CITY OF ALBUQUERQUE

May 7, 2024

Re: Blake's Lotaburger
641 Coors Blvd. NW
Traffic Circulation Layout
Architect's Stamp 03-14-24 (J10-D052)

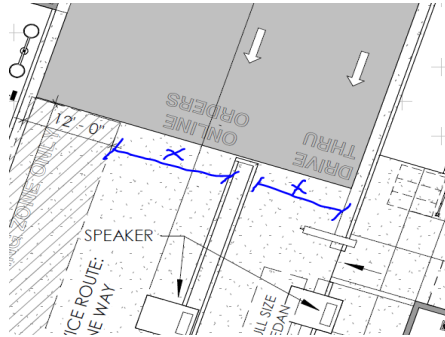
3. Please provide copy of shared access easement approval.
4. Site access off Fortuna Rd: please provide site access ramps details and reference city std dwg.
5. The ADA access aisles shall have the words **"NO PARKING"** in capital letters, each of which shall be at least one foot high and at least two inches wide, placed at the rear of the parking space so as to be close to where an adjacent vehicle's rear tire would be placed. (66-1-4.1. B NMSA 1978)

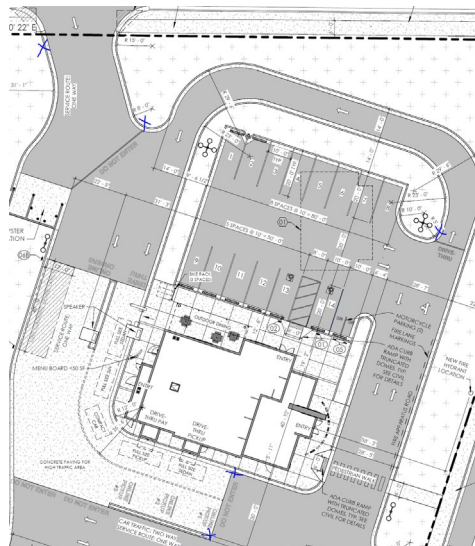
6. Please show on the site plan each drive-thru lane width.
